Access Compliance Report

Public Rights-of-Way

(Curb Ramps)

Intersection ID: 23470	Main Street: BRANDON_FOREST_DR	Cross Street: STRADBROOK_DR	Location: NW
ADA ID: D78ADA912A9D	Ramp Type: PerpDiag	Initial Pass/Fail: Fail	Overall Compliance: No
Severity Score: 12.5			
Codes/Mitigation Info/Possible Solution		Field Measurements/Component Compliance

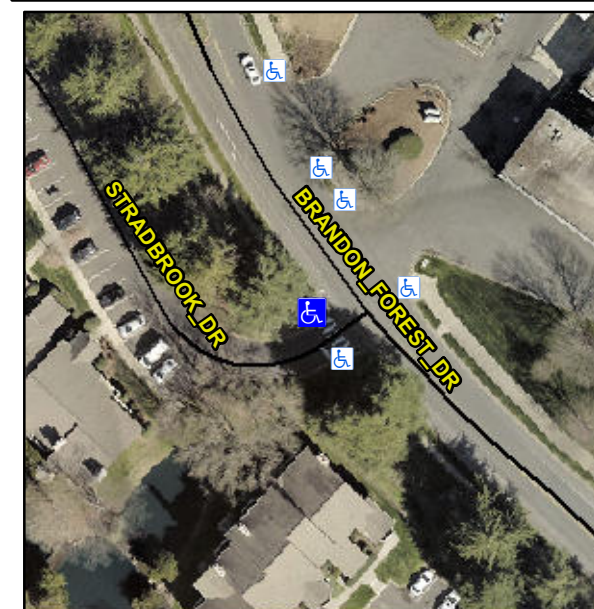
Compliance	Description	Data	Compliance	Description	Data
N/A	Ramp Length (in)	84.0	Yes	Ramp Slope (%)	6.4
Yes	Ramp Width (in)	48.0	No	Ramp XSlope (%)	5.5
N/A	Flare Type LT	N/A	N/A	Flare Type RT	N/A
N/A	Flare Slope LT (%)	N/A	N/A	Flare Slope RT (%)	N/A
N/A	Flare Traversable LT?	N/A	N/A	Flare Traversable RT?	N/A
N/A	Landing Length (in)	N/A	N/A	DWS Provided?	N/A
N/A	Landing Width (in)	N/A	N/A	DWS Contrast?	N/A
N/A	Landing Slope (%)	N/A	N/A	DWS Length (in)	N/A
N/A	Landing X Slope (%)	N/A	N/A	DWS Full Width?	N/A
N/A	Landing Curb? (Y/N)	N/A	N/A	DWS Offset (in)	N/A
N/A	Shared Landing?	N/A			
N/A	Gutter Ponding?	N/A	N/A	Gutter Slope (%)	N/A
N/A	Gutter Lip Ht (in)	N/A	N/A	Gutter X Slope (%)	N/A
N/A	Painted X Walk1?	Yes	N/A	Painted X Walk2?	No
	X Walk 1 Direction	To SE		X Walk 2 Direction	To E
N/A	X Walk 1 Width (in)	96.0	N/A	X Walk 2 Width (in)	N/A
	X Walk 1 Slope (%)	5.0		X Walk 2 Slope (%)	1.3
	X Walk 1 X Slope (%)	0.8		X Walk 2 X Slope (%)	5.8

N/A	Ramp inside XWalk1?	Yes	N/A	Ramp inside XWalk2?	N/A
	Road Slope (%)	1.6	N/A	Clear Space?	N/A
	Road X Slope (%)	4.2	N/A	Clear Space to XWalk (in)	N/A
N/A	Any Obstructions?	N/A	N/A	Storm Grate/Utility Hazard?	N/A
	Obstruction Type			Storm Grate/Utility Type	
		N/A			N/A
		Yes		Surface Condition? (G/P)	Good

Remove & Replace Curb Ramp With Two New Directional Ramps or Equivalent.

R304.5.3
